Re: Starpoint No. 2 Mine Resource Recovery and Protection Plan (R2P2), Underground
 Exploratory Drilling, Minor Modification

FCL MODIFICATION
UTU 64263

Approved Mine Map

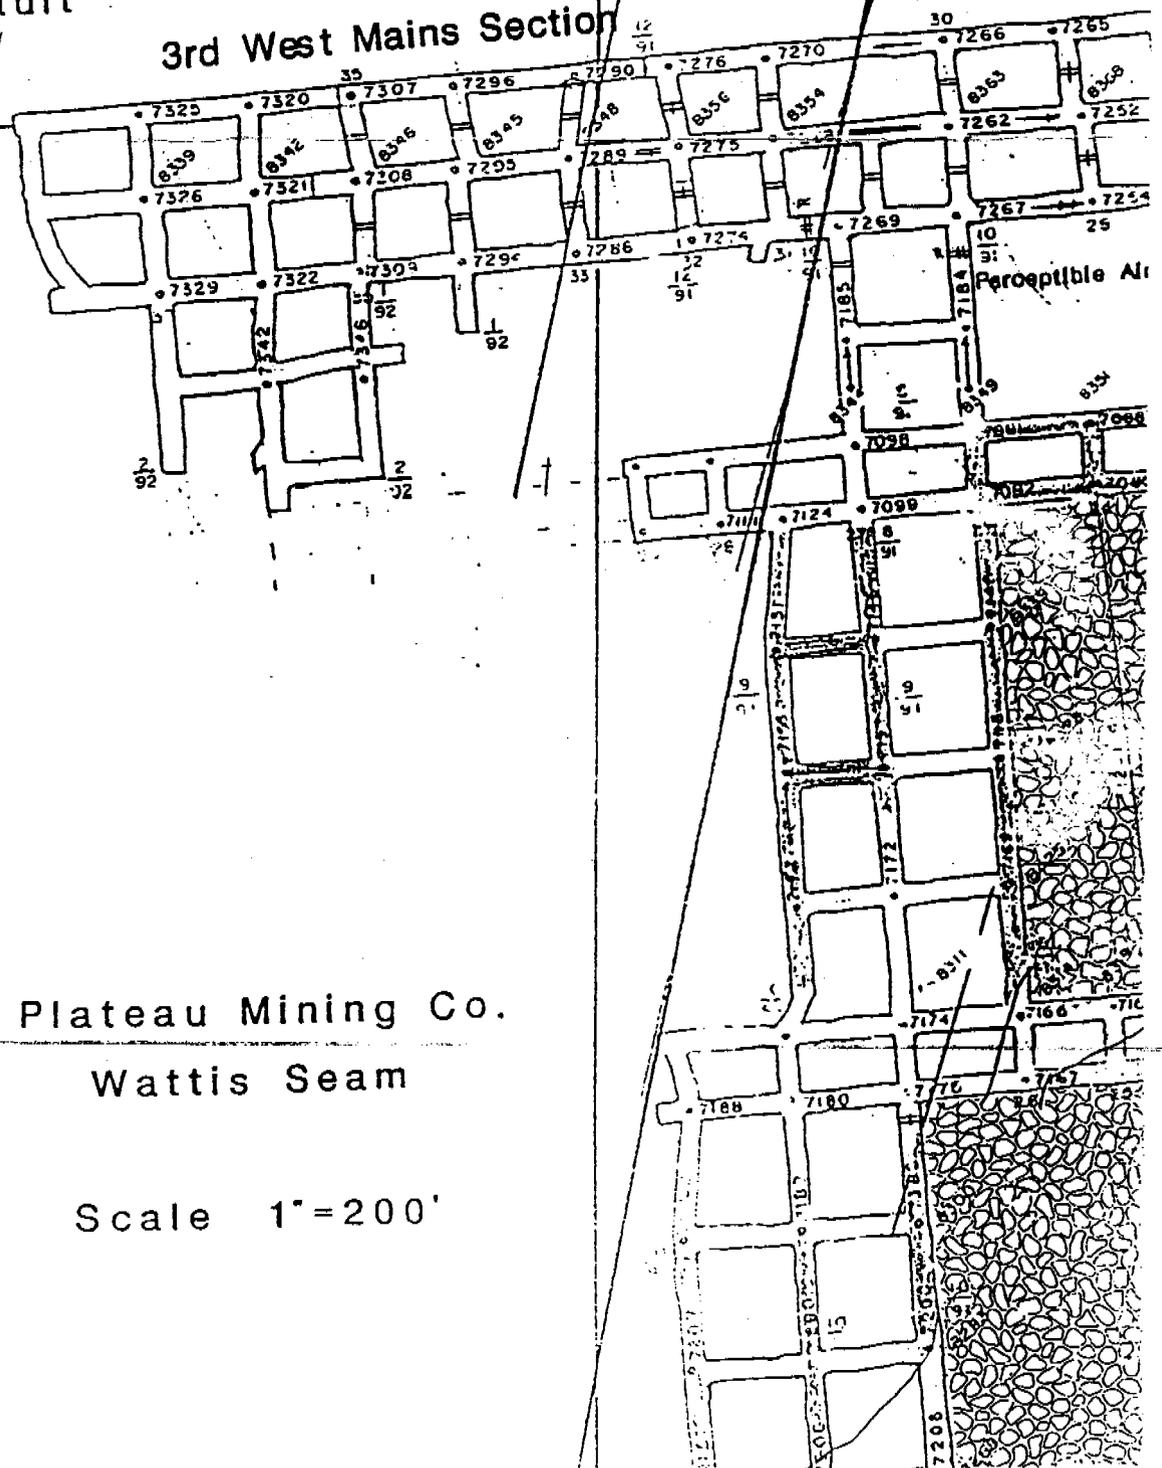
The requested modification calls for drilling a minimum of two underground exploratory longholes/coreholes west from the end of the 3rd West Main entries. One 400-foot horizontal core hole and one 600-foot inclined core hole are planned. The holes will be 4 inches in diameter and will be cored the length of the hole. Cyprus includes in the proposal measures to prevent water inflow into the mine workings from the fault zones encountered.

Cyprus states the holes are to locate the Pleasant Valley fault system and identify significant structural features of the fault. The inclined hole is planned to intercept the downthrown coal on the other side of the fault. Cyprus contends that the information gathered from the drilling will help identify potential coal reserves on the other side of the fault and the possibility of accessing any reserves.

The BLM agrees with the proposal, as new information concerning the coal and the fault system will help determine if areas have future potential for coal recovery. The drilling plan contains standard industry methods of plugging drill holes that would prevent water inflows into the mine. Following the proposed plan would cause no surface impacts and would not change the recovery of Federal leased coal.

modification is approved contingent on Plateau submitting the results of the information obtained from the drilling to the BLM. If more than two holes are needed, please notify this office. A copy of the approved mining plan map for the area is enclosed.
